# TECHNICAL EVALUATION REPORT

## EVALUATION OF MCGUIRE UNITS 1 AND 2 UNDervoltage TRIP ATTACHMENT FAILURES

NRC DOCKET NO. 50-369, 50-370

July 13, 1983

Figure 3. UVTA from Face with Reset Lever Bracket Removed

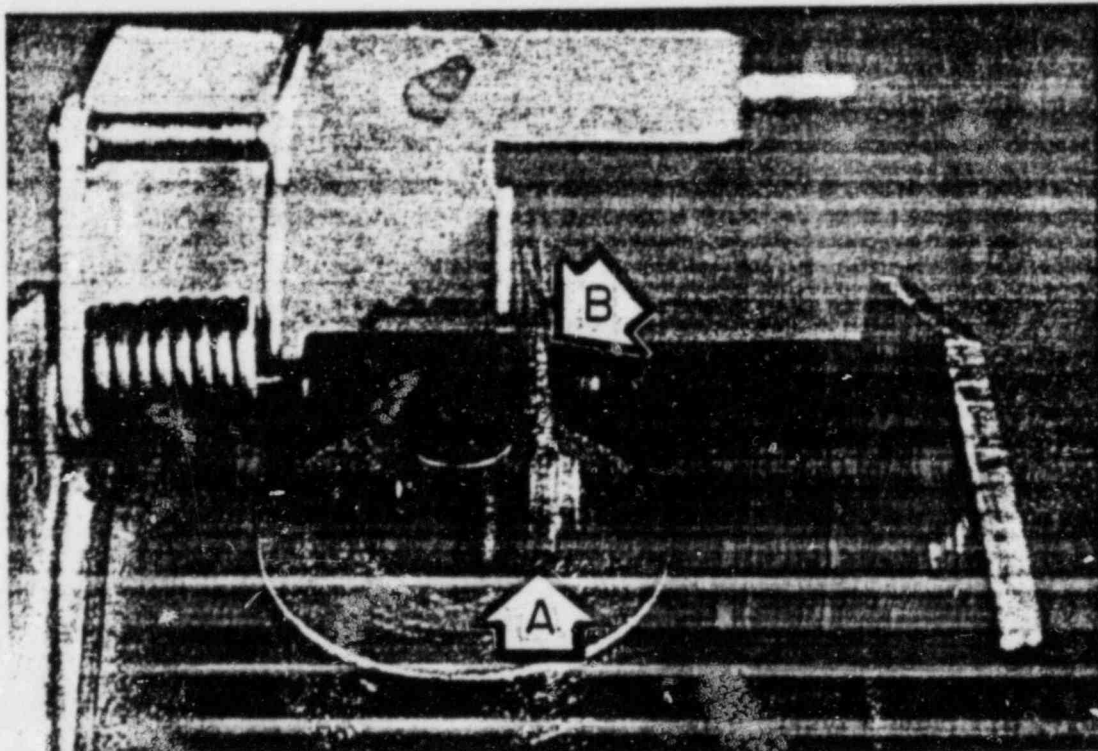
The first failure mode was attributed to inadequate clearances between components of the UVTA. Two internal clearance problems were found: inadequate clearance between the roller bracket and the moving core (see Figure 1 for nomenclature and Figure 3 for photograph of components with clearance problems), and inadequate clearance between the roller bracket and the spacer bushing on the roller bracket pivot pin.

- A. Moving Core to Roller Bracket Clearance
- B. Spacer Bushing to Roller Bracket Clearance

The manufacturer's corrective action for the second failure mode was to reject devices with less than 0.018-in clearance between the moving core and the roller bracket arm and to establish a minimum clearance of 0.030 in between the roller bracket and the brass bushing. This clearance is required to prevent the bushing from causing a lateral force that pinches the bracket between the frame and the bushing. This pinching would act as a braking mechanism and prevent unlatching of the UVTA.

Figure 4. DS-416 Undervoltage Trip Attachment Showing Location for Static Pull Force Measurement

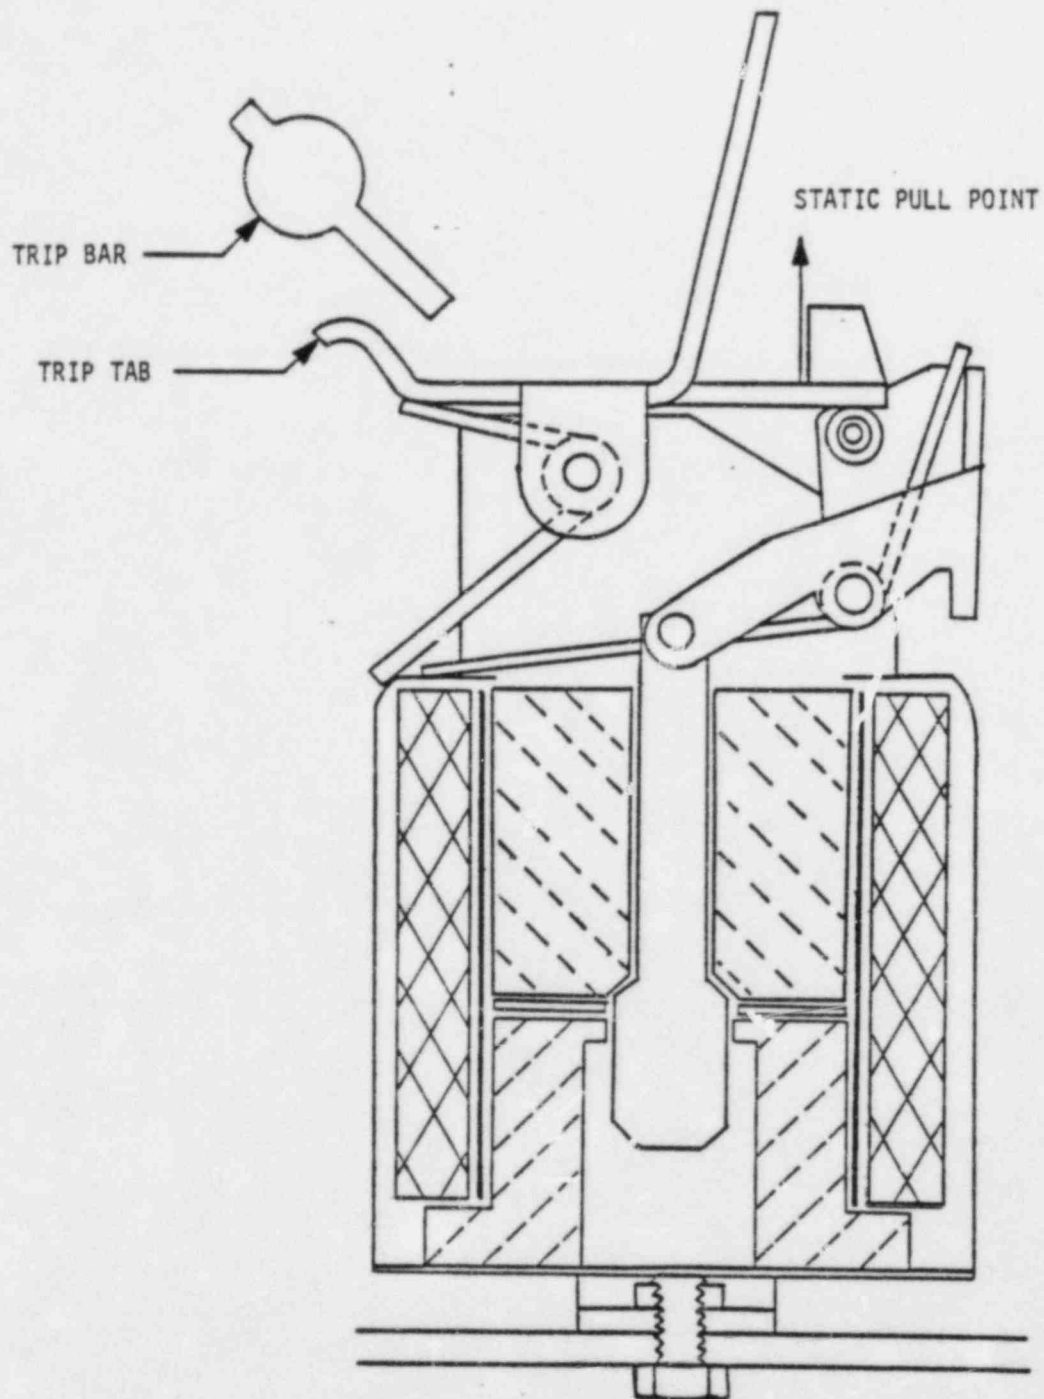
The measurement of available output force that can be performed on the McGuire plant circuit breakers is a static pull of the reset lever from the

point just in front of the tab that is above the roller bearing when the device is latched (see Figure 4). Duke personnel perform this test with the UVTA unlatched, causing the trip spring to be in the most relaxed operating state. This reading is conservative with respect to a reading taken with the trip spring in the latched position and compensates for the pivot point frictions that would reduce initial output force slightly. A multiplier of 0.88 must be used to adjust these forces to account for lever arm differences.

Figure 5. DS-416 UVTA in Reset Position  
(Partial View Showing Critical Measurements)

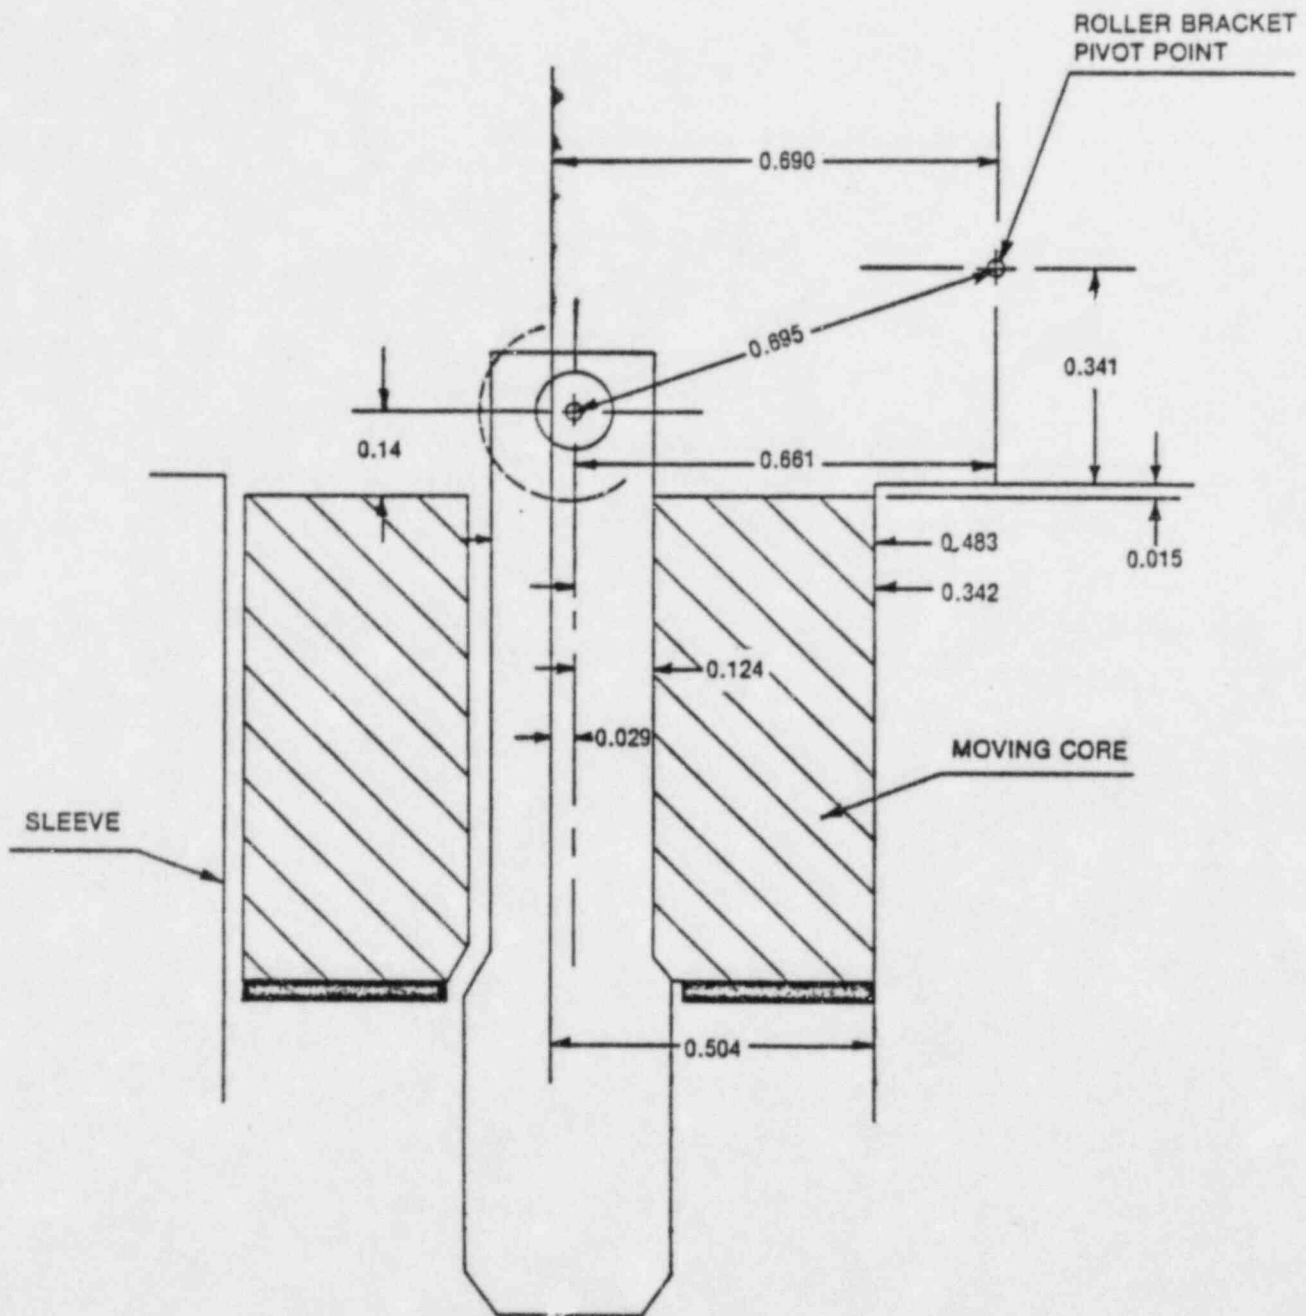
The measurements obtained for the critical areas are shown in Figure 5. The position shown is for the reset condition where the roller bracket is pressed down against the operating rod. With the rod firmly against the side of the hole in the moving core, the core would clear the sleeve by 0.0086 in. However, the diameter of the core does vary by 0.010 in, which would reduce the clearance to 0.0036 in.

As the roller bracket is rotated toward unlatching by the roller bracket spring, the operating rod is pulled toward the center line of the sleeving; at the extreme, the center line of the rod will be 0.005 in past the center line of the sleeving. This motion did not show any tendency to prevent the core

Figure 7. Torque Developed by Roller Bracket Spring versus Angle of Travel of Roller Bracket

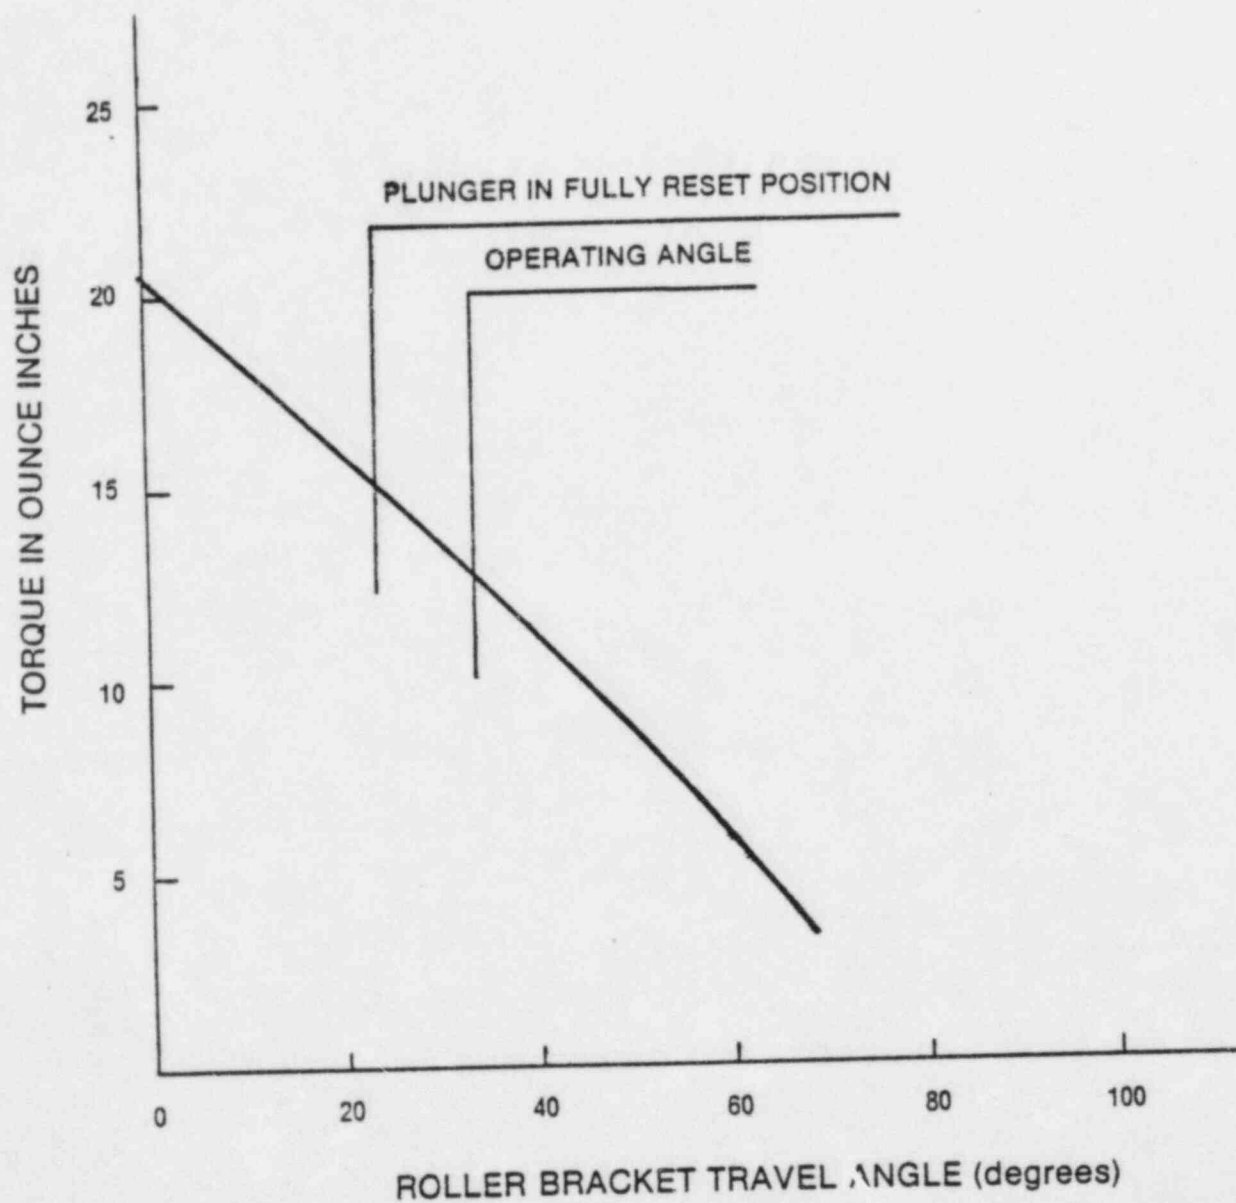
The roller element bearing is not symmetrical because the rollers extend to one end of the bearing housing, but only come to about 75% of the distance from the other end. With the rollers directly under the reset lever, the system will trip consistently. When the bearing is reversed on the mounting shaft, the reset lever now applies force at one end of the rollers. In this configuration, the assembly can be made to fail.

Further confirmation of the effect of increased friction was studied by taking a brass brushing with the same dimensions as the roller bearing and placing it on the bearing shaft. The assembly could readily be made to fail. The maximum torque level for the rolling friction can then be determined from Figure 7. Since the slope of  $T_{RBS}$  is less than that for the  $T_{TS}$ , the rolling friction would have to be less than 10.6 ounce-in at an angle of -6 degrees.

5. The roller bracket to roller bearing frictional forces should be reviewed and evaluated. Potential for failure to operate should be determined, and any significant potential for failure should be eliminated. Data available at the time of writing of this report indicated that there is no immediate short-term concern for roller bearing failures and that this evaluation could be performed in conjunction with the life testing program.
